OHIO TURNPIKE COMMISSION

ADDENDUM NO. 1

CONTRACT NO. 39-12-02
WESTBOUND RIGHT TWO (2) LANES AND SHOULDER RECONSTRUCTION
MILEPOST 164.82 TO MILEPOST 169.74
CUYAHOGA COUNTY, OHIO

**OHIO TURNPIKE COMMISSION
ADDENDUM NO. 1
CONTRACT NO. 39-12-02**

EXHIBIT A ALLOWABLE AREAS for MATERIAL CRUSHING & STOCKPILES

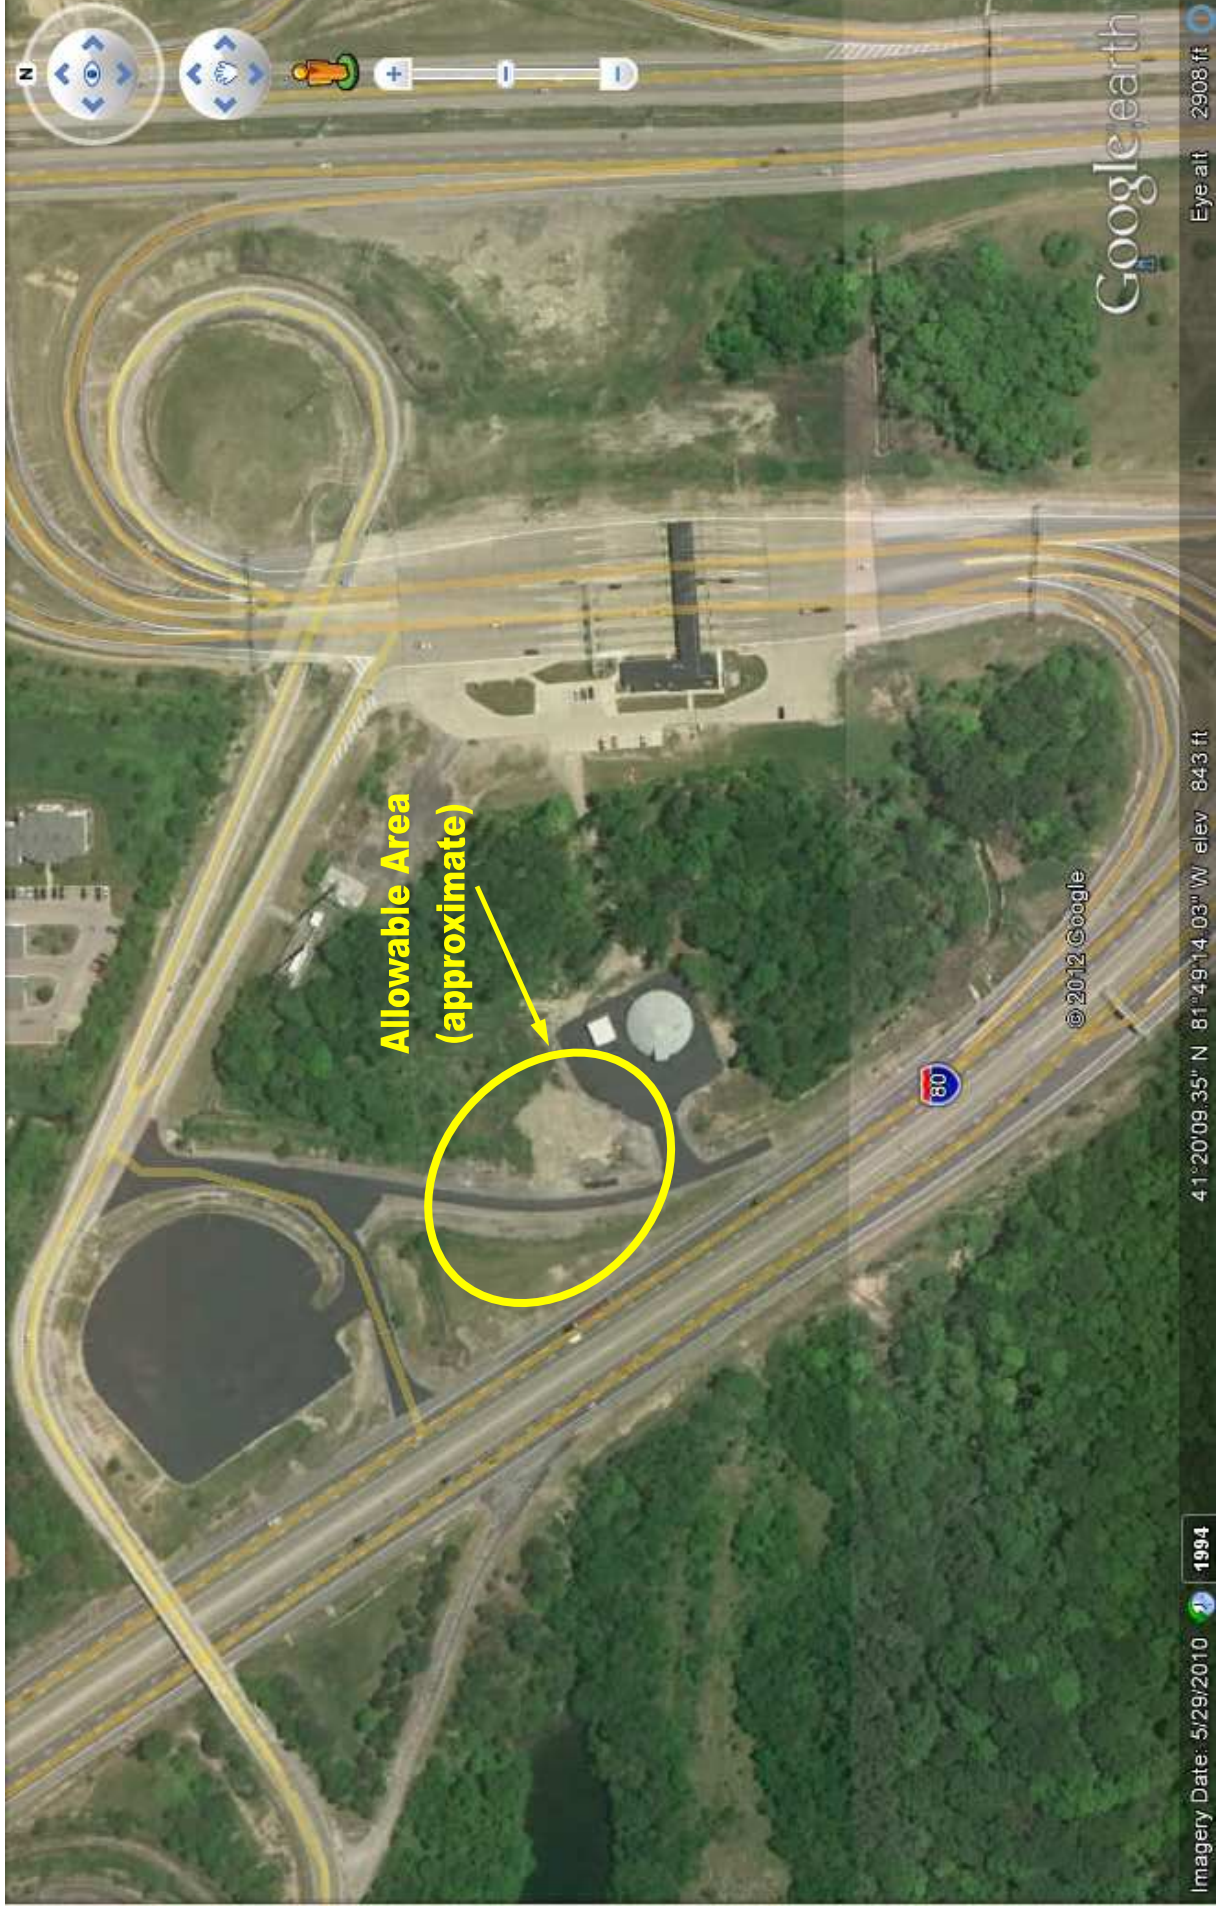
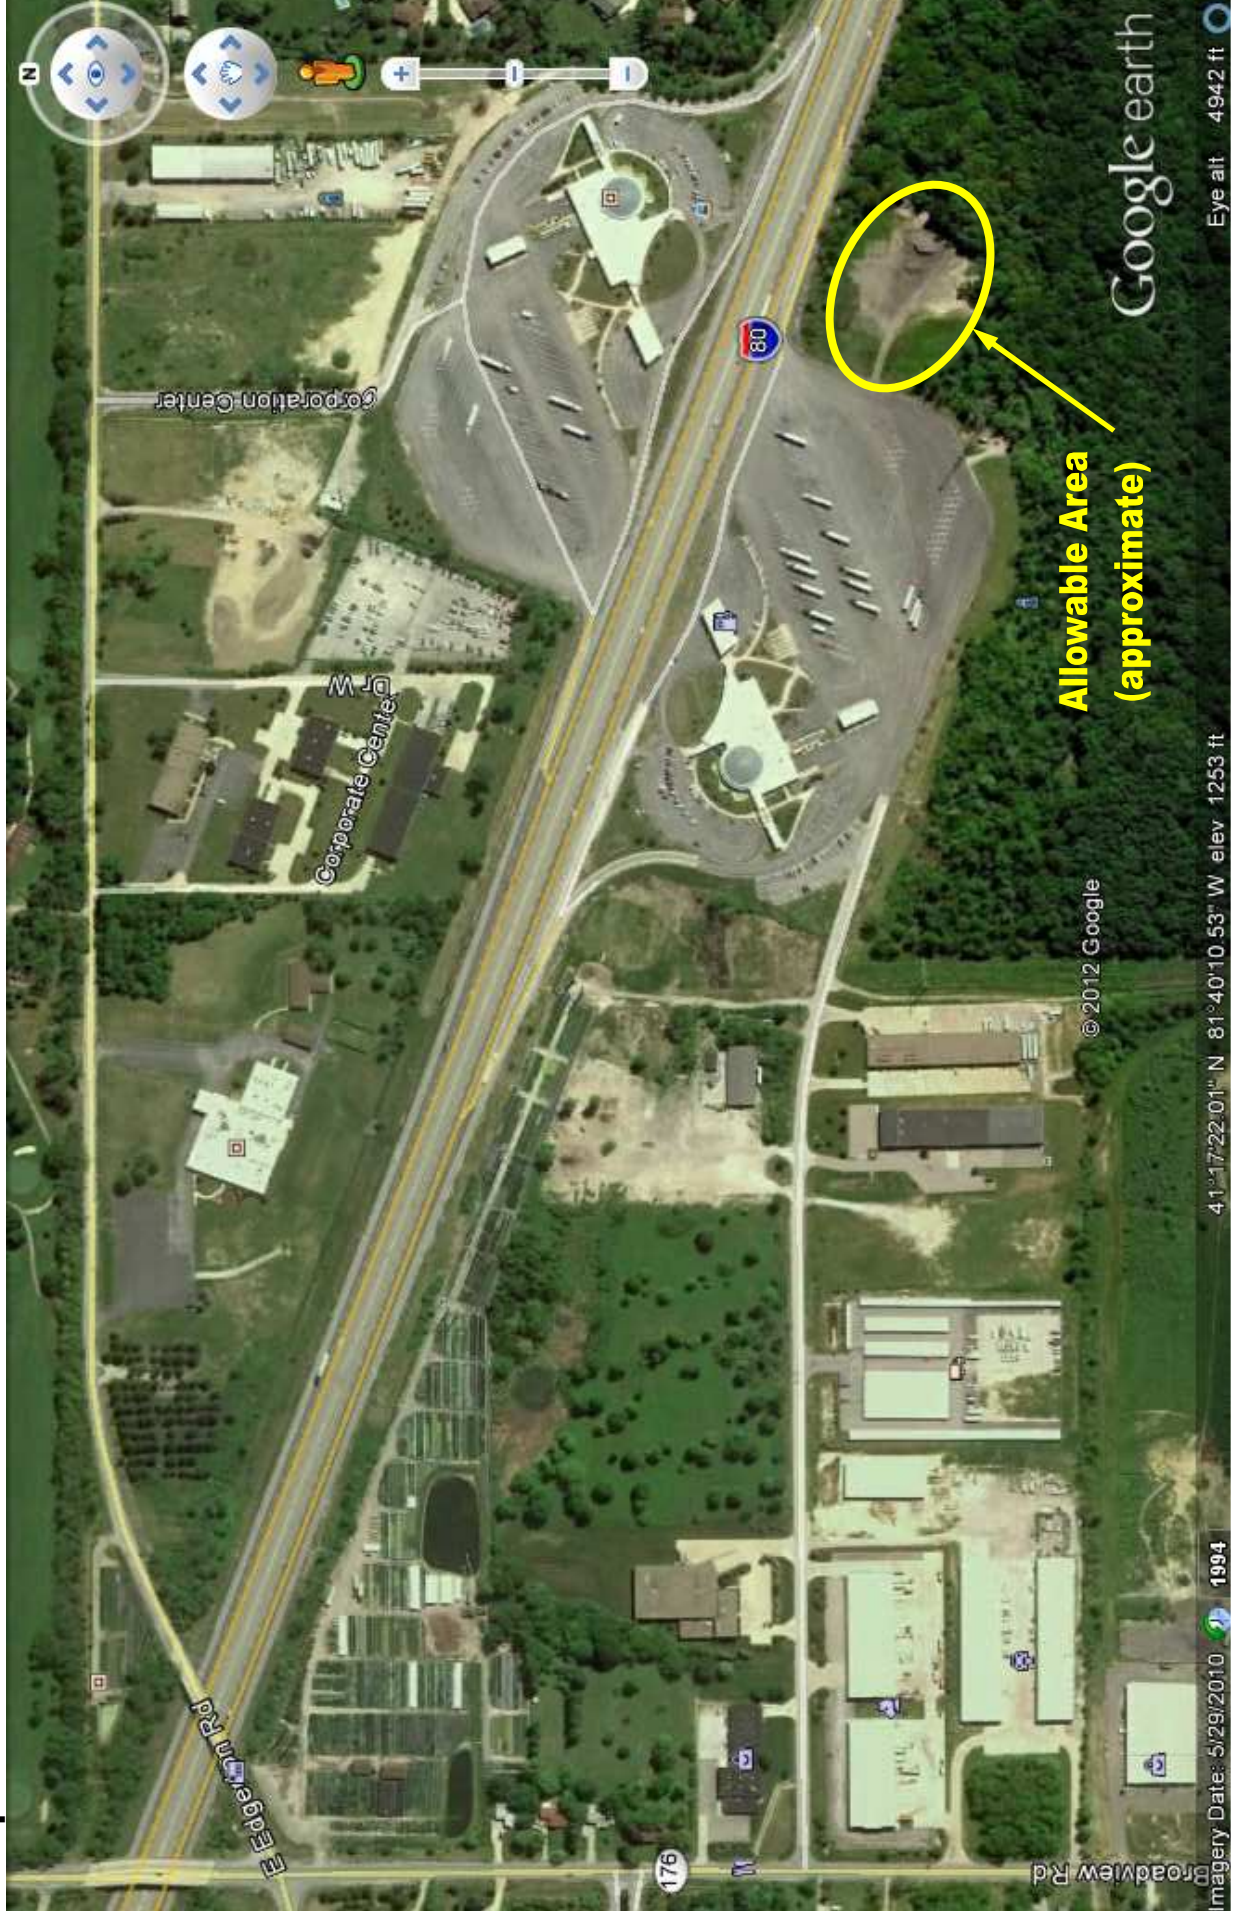
Q#3 Ref. 162 and 163: the plan sheet 9 SP304 note says "all excess material shall be the property of the commission and shall be stockpiled at a location within the limits of the project as directed by the Chief Engineer". The physical jobsite (MP 164.82 to 169.74) limits have very limited areas for storing materials. Will the OTC please consider making available areas within the IR 71/US 42 and IR 77/SR 21 interchanges for crushing and stockpiling?

Q#11 On sheet 8 of the plans under ITEM SP304 – 10" RECYCLED AGGREGATE BASE, AS PER PLAN it states "all excess material shall be the property of the commission and shall be stockpiled at a location within the limits of the project". Will this area be available for crushing/processing the broken concrete or will the material need to be crushed offsite and then returned to the project?

Q #12 Are there any other turnpike property areas for concrete plant and/or crushing operations available to the contractor within the project limits or close to the project? If so, where are these locations? Will City or Township zoning be required on turnpike property or is it exempt from local zoning regulations?

Q#13 Where is the area that has been designated for stockpiling the excess crushed concrete if the alternate is accepted?

A#3 *The Commission has identified two (2) areas within the Turnpike right-of-way that are near the Project site. Exhibit A (attached) identifies Allowable Areas for Material Crushing and Stockpiles, and lists requirements for the use of these areas.*

Requirements for Use of Allowable Areas:

- **Temporary Access Credit is not required for use of these areas**
- **All work and costs associated with the use of these areas are the Contractor's sole responsibility**
- **Approximate limits of Allowable Areas are outlined in yellow on the following pages**
- **Area(s) used by Contractor must be restored to original condition upon Project completion**
- **Contractor must adhere to all applicable (Local and Turnpike) vehicle weight limits**
- **Contractor must adhere to all applicable local laws and ordinances**
- **After Contract is awarded, Contractor must submit a comprehensive plan for use of Allowable Area(s) prior to construction and subject to the approval of the Chief Engineer.**

Plan shall include, at a minimum:

- **drainage modifications**
- **dust control procedures**
- **ingress/egress routes**
- **location of flaggers**
- **approximate locations and dimensions of stationary equipment**
- **approximate locations and dimensions of stockpiles**
